CALIFORNIA COASTAL COMMISSION

STAFF REPORT: REGULAR CALENDAR

APPLICATION NO.: 5-98-043

PROJECT DESCRIPTION: Installation of a sixty-five foot long groin wall placed perpendicular to the coast line and vertically into the beach. The groin wall consists of tongue and groove recycled plastic panels which are eight feet tall by ten feet in length and are three inches thick. The groin wall will be topped with a 2" by 12" wooden cap.

Figure 1

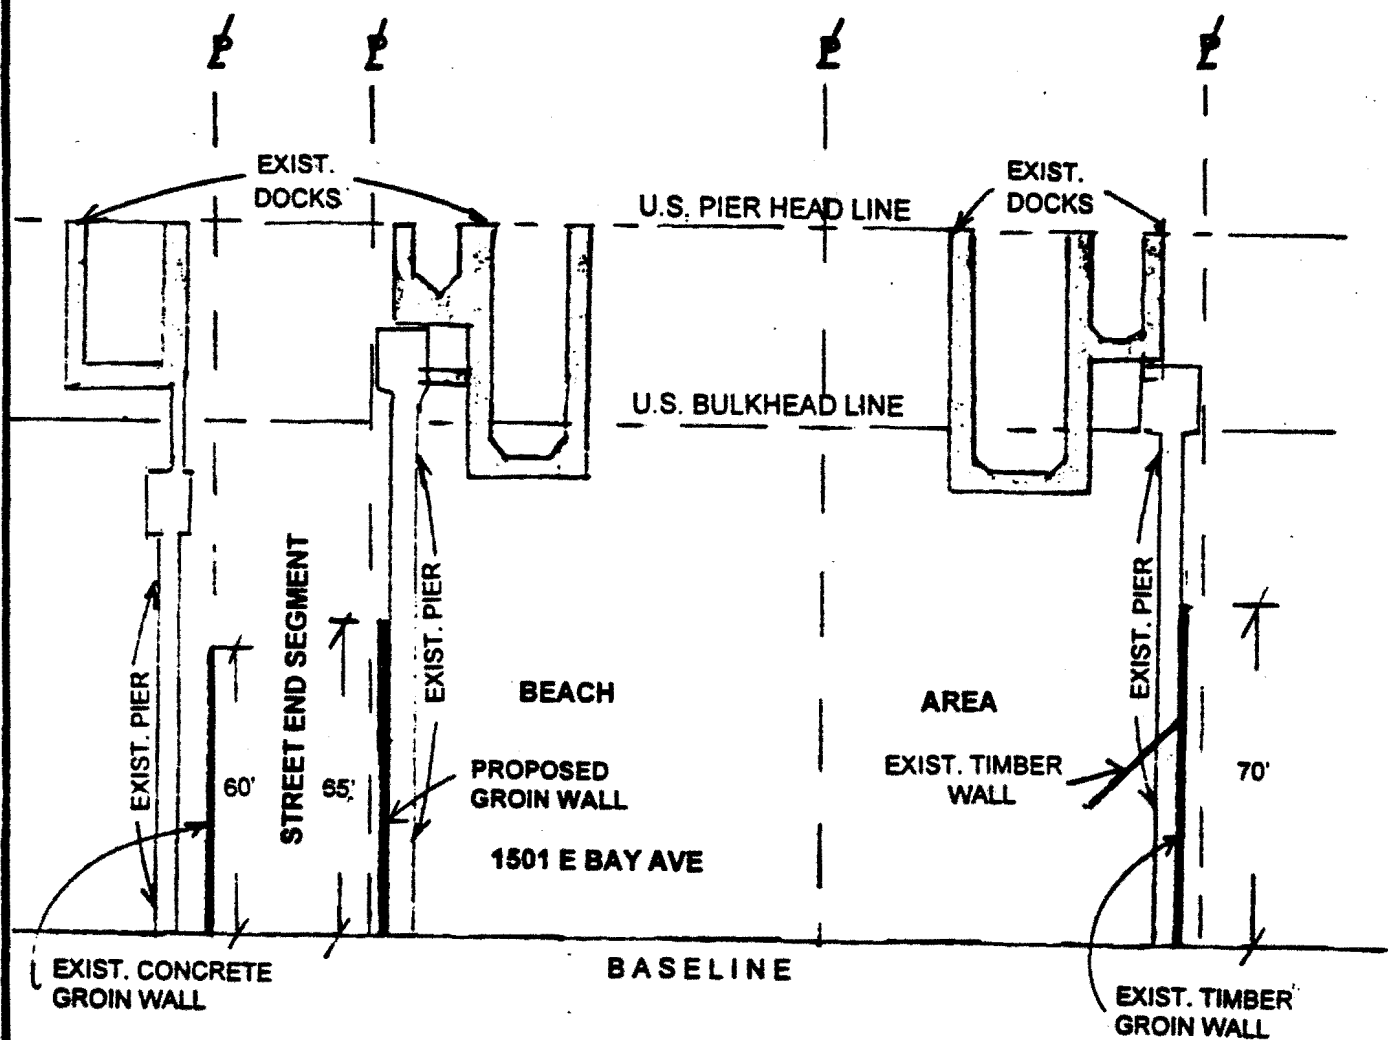
Figure 1 shows the plan view of the revised groin wall. The wall structure, with a top elevation at +9 feet, MLLW¹, extends out 65 feet along the west side of the existing pier. The beach elevation at the wall end location is at about +2 feet, MLLW, as measured on January 4, 1999. The existing pier extends further out 60 feet approximately with a deck elevation at about +9 feet, MLLW. A boat berthing area is connected to the pier through an access gangway, as illustrated in Figure 1.

The proposed 65-foot groin wall will divide the shoreline reach between the two existing groin walls into an approximate 160-foot shoreline segment covering two residential lots and a 30-foot street end lot (see Figure 1). Since the length of the proposed 65-foot groin wall is on the same order of magnitude as the two neighboring walls (60 and 70 feet respectively), it suggests that little, if any, additional impacts to coastal processes would occur due to the presence of the proposed groin wall.

EXHIBIT No. 4
Application Number: 5-98-043
Cross Section
California Coastal Commission

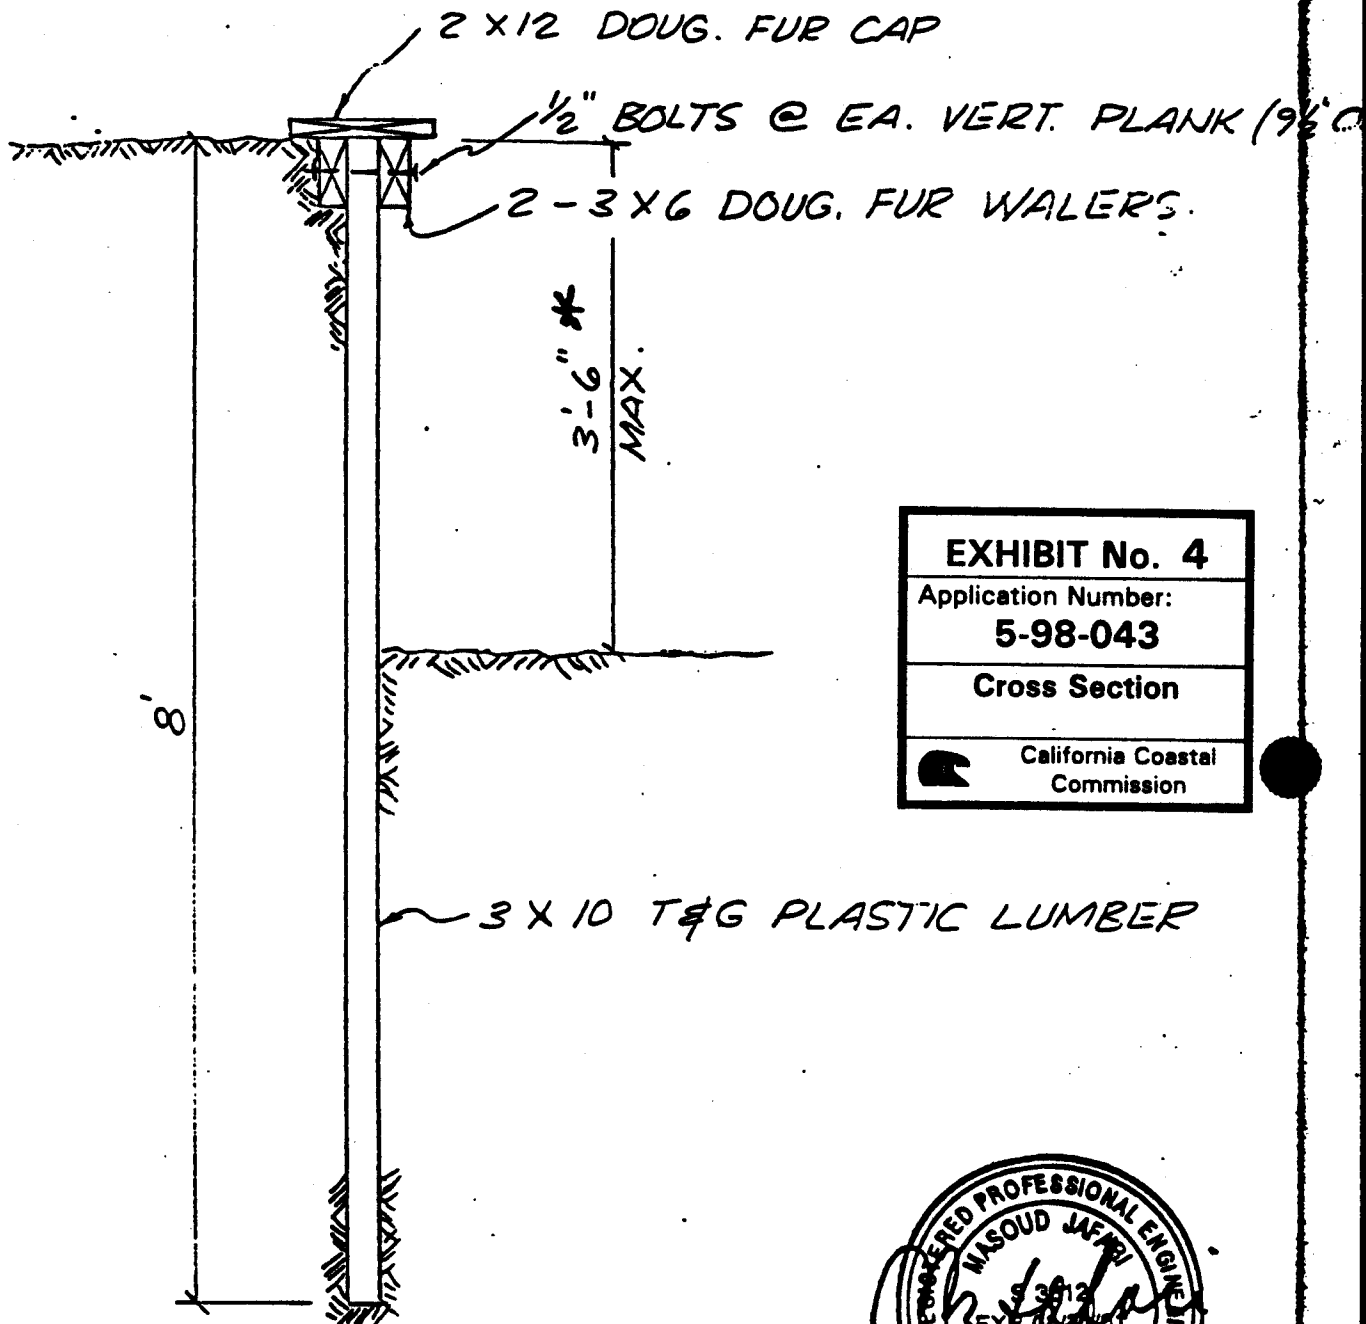
Installation of a sixty-five foot long groin wall vertically into a private beach (Exhibit 3, Exhibit 3 (Figures 1), and Exhibit 4). The proposed groin wall would consist of tongue and groove recycled plastic panels which are eight feet tall by ten feet in length and are three inches thick (Exhibit 4). The individual panels would be hand-jetted into place with a jet pump. The groin wall would be topped with a 2" by 12" wooden cap. The groin wall would be placed perpendicular to the shoreline beneath the existing pier leading to the applicant's berthing slip. The groin wall would extend from an existing concrete sidewalk which is at +8' MLLW sixty-five feet seaward terminating at the +2' MLLW water mark. The top of the groin wall would be at elevation +9' MLLW. MLLW denotes Mean Low Lower Water which is about 2.7 feet below Mean Sea Level. The tidal range at the subject site is from 0' to +5' MLLW. Approximately twenty-five feet of the proposed groin wall would be seaward of the MHTL.

* Adjacent boat slip area shall be dredged &
material placed against this groin whenever
needed 3' to 4'
